# **OMA relaxation for high extinction ratio transmitters**

John Johnson, Broadcom Inc.

100G-EPON

This contribution is in support of comments by the author against draft D1.1.

# PR30 US: Cooled ONU TX

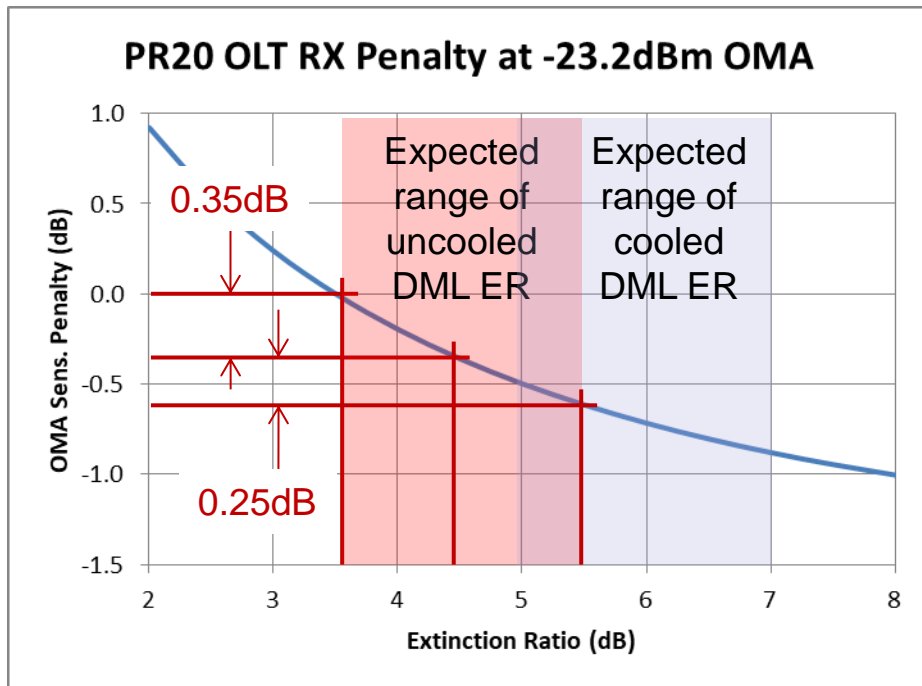
- RX OMA Sens. (min) = -24.8dBm at minimum ER = 5dB.
- ONU TX is expected to be a **cooled DML** for PR30 PMDs
- Cooled DML ER can range from 5dB (min) to ~7dB at the high end.
- ONU TX with ER  $\geq 6$ dB need **0.2dB lower OMA** for same OLT RX sensitivity as an ONU TX with ER = 5dB.
- **Propose relaxation of 0.2dB in OMA minus TDP (min) for PR30 ONU TX with ER  $\geq 6$ dB.**

Description	Value	Unit
Launch power in OMA minus TDP, each lane (min):		
for extinction ratio $\geq 6$ dB	4	dBm
for extinction ratio $< 6$ dB	4.2

# PR20 US: Uncooled ONU TX

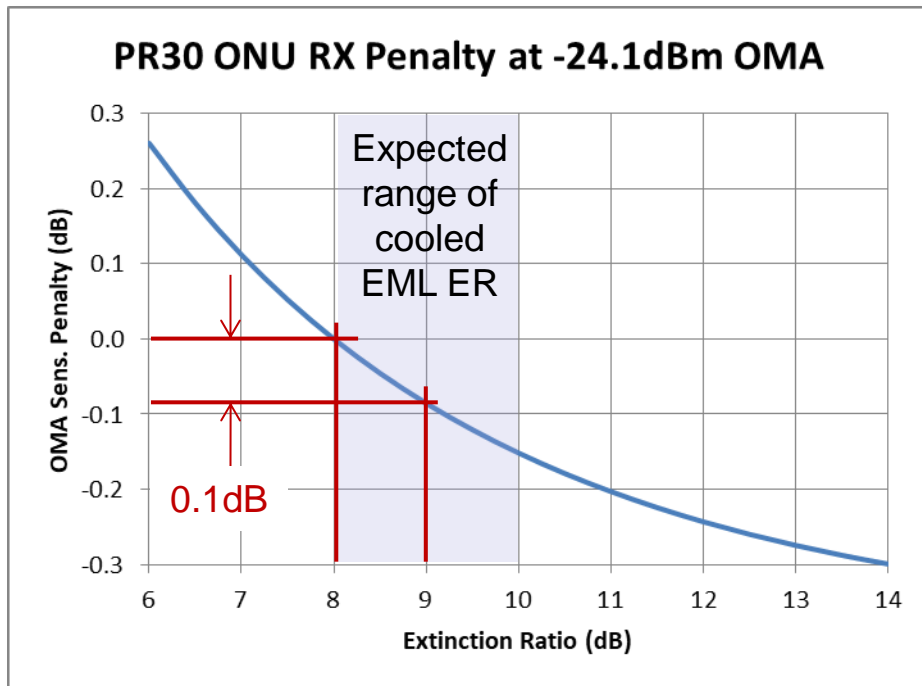
- RX OMA Sens. (min) = -23.2dBm at minimum ER = 3.5dB.
- ONU TX is expected to be an **uncooled DML** for PR20 25G PMDs, but 50/50G ONUs may use **cooled DMLs** to overcome mux losses.
- Uncooled DML ER can range from 3.5dB (min) to ~5.5dB at the high end. Cooled DML ER can be up to ~7dB.
- ONU TX with ER > 4.5dB need **0.35dB lower OMA** for same OLT RX sensitivity as an ONU TX with ER = 3.5dB. (Cooled) ONU TX with ER > 5.5dB need 0.6dB lower OMA.
- **Propose relaxation of 0.3dB in OMA minus TDP (min) for PR20 ONU TX with ER  $\geq 4.5$ dB, and 0.6dB relaxation for ER  $\geq 5.5$ dB.**

Description	Value	Unit
Launch power in OMA minus TDP, each lane (min):		
for extinction ratio $\geq 5.5$ dB	0.2	
for extinction ratio $\geq 4.5$ dB	0.5	dBm
for extinction ratio $< 4.5$ dB	0.8

# PR30 DS: Cooled EML TX

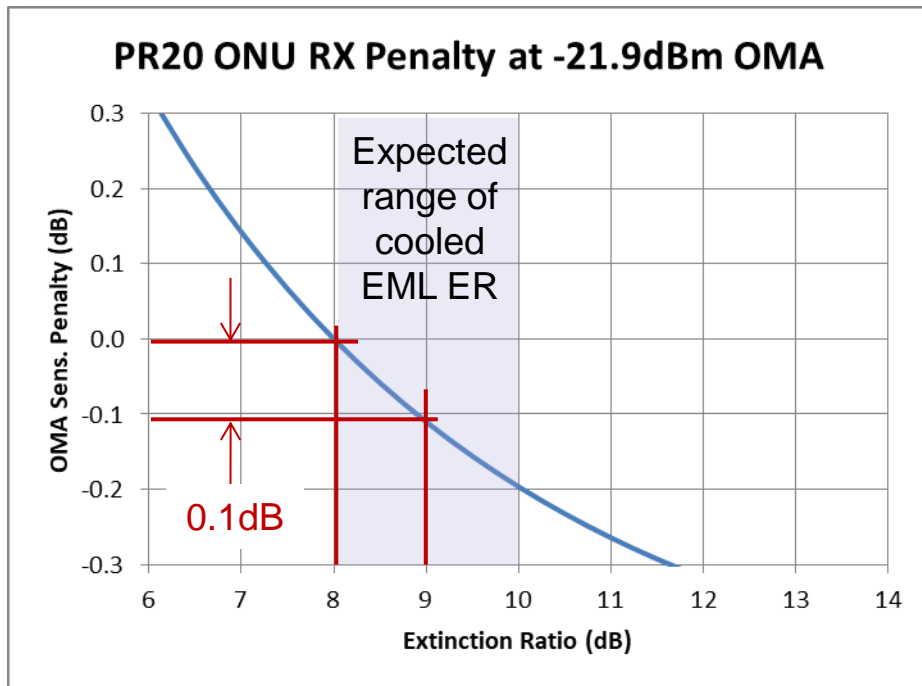
- RX OMA Sens. (min) = -24.1dBm at minimum ER = 8dB.
- OLT TX is expected to be a **cooled EML**.
- Cooled EML ER can range from 8dB (min) to ~10dB at the high end.
- OLT TX with ER > 9dB need **0.1dB lower OMA** for same ONU RX sensitivity as an OLT TX with ER = 8dB.
- **Propose relaxation of 0.1dB in OMA minus TDP (min) for PR30 OLT TX with ER ≥ 9dB.**

Description	Value	Unit
Launch power in OMA minus TDP, each lane (min):		
for extinction ratio ≥ 9 dB	4.8	dBm
for extinction ratio < 9 dB	4.9

# PR20 DS: Cooled EML TX

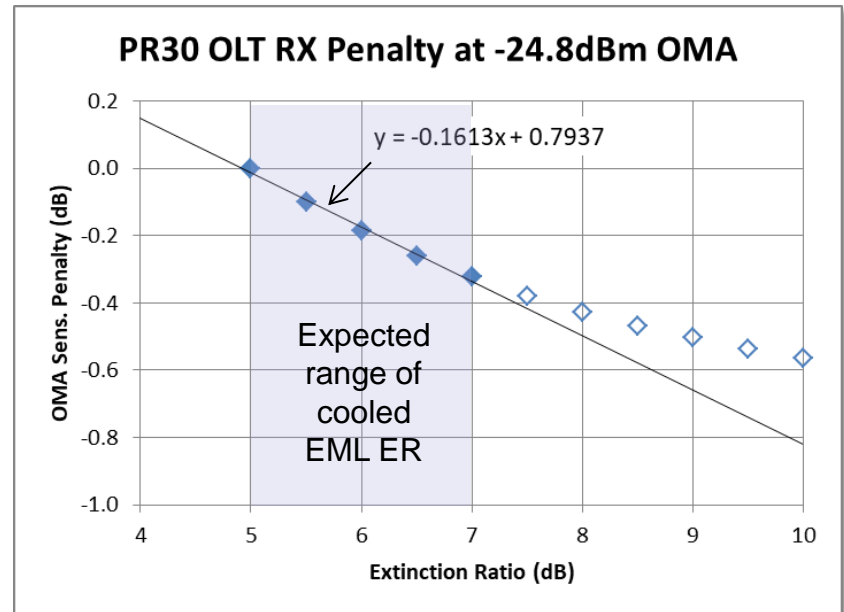
- RX OMA Sens. (min) = -21.9dBm at minimum ER = 8dB.
- OLT TX is expected to be a **cooled EML**.
- Cooled EML ER can range from 8dB (min) to ~10dB at the high end.
- OLT TX with ER > 9dB need **0.1dB lower OMA** for same ONU RX sensitivity as an OLT TX with ER = 8dB.
- **Propose relaxation of 0.1dB in OMA minus TDP (min) for PR20 OLT TX with ER ≥ 9dB.**

Description	Value	Unit
Launch power in OMA minus TDP, each lane (min):		
for extinction ratio ≥ 9 dB	2	dBm
for extinction ratio < 9 dB	2.1
